Access Compliance Report

Public Rights-of-Way

Intersection ID: 49234	Main Street: NEW_CALVINE_ST	Cross Street: N_BREVARD_ST	Location: S
ADA ID: 59CFAEB6681D	Ramp Type: PerpDiag	Initial Pass/Fail: Fail	Overall Compliance: No
Severity Score: 1.25			
Codes/Mitigation Info/Possible Solution		Field Measurements/Component Compliance

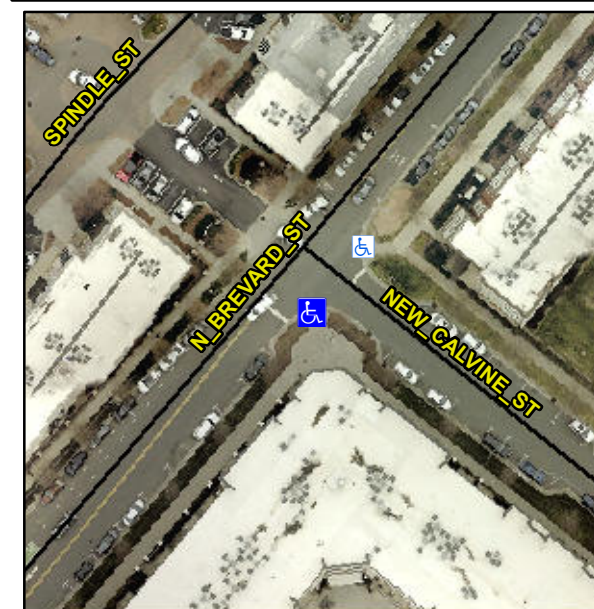
Not Found, R304.5.3

Compliance	Description	Data	Compliance	Description	Data
N/A	Ramp Length (in)	96.0	Yes	Ramp Slope (%)	8.1
Yes	Ramp Width (in)	48.0	No	Ramp XSlope (%)	3.0
N/A	Flare Type LT	N/A	N/A	Flare Type RT	N/A
N/A	Flare Slope LT (%)	N/A	N/A	Flare Slope RT (%)	N/A
N/A	Flare Traversable LT?	N/A	N/A	Flare Traversable RT?	N/A
N/A	Landing Length (in)	N/A	N/A	DWS Provided?	N/A
N/A	Landing Width (in)	N/A	N/A	DWS Contrast?	N/A
N/A	Landing Slope (%)	N/A	N/A	DWS Length (in)	N/A
N/A	Landing X Slope (%)	N/A	N/A	DWS Full Width?	N/A
N/A	Landing Curb? (Y/N)	N/A	N/A	DWS Offset (in)	N/A
N/A	Shared Landing?	N/A			
N/A	Gutter Ponding?	N/A	N/A	Gutter Slope (%)	N/A
N/A	Gutter Lip Ht (in)	N/A	N/A	Gutter X Slope (%)	N/A
N/A	Painted X Walk1?	No	N/A	Painted X Walk2?	No
	X Walk 1 Direction	To NE		X Walk 2 Direction	To NW
N/A	X Walk 1 Width (in)	N/A	N/A	X Walk 2 Width (in)	N/A
	X Walk 1 Slope (%)	1.7		X Walk 2 Slope (%)	3.4
	X Walk 1 X Slope (%)	1.9		X Walk 2 X Slope (%)	2.6

Remove & Replace Curb Ramp With Two New Directional Ramps or Equivalent.
